# Access Compliance Report

## Public Rights-of-Way

### (Pedestrian Signals)

Intersection ID: N/A	Main Street:	Cross Street: N/A	Location: N/A
ADA ID: 4A84FFD7C38E	Signal Type: One Push Button-Non APS	Overall Compliance: No	Severity Score: BTN 1: N/A BTN 2: N/A No BTN: N/A
Codes/Mitigation Info/Possible Solution		Field Measurements/Component Compliance

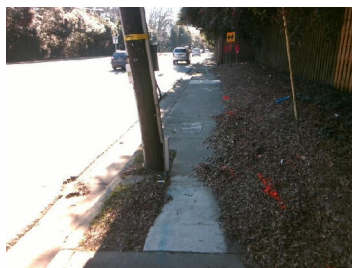
PROW/ADA: TMUTCD 4e.08, R404.1, R404.7.3

Possible Solutions: Replace Signal Push Button With APS Button on New Post. Remove & Relocate Sign.
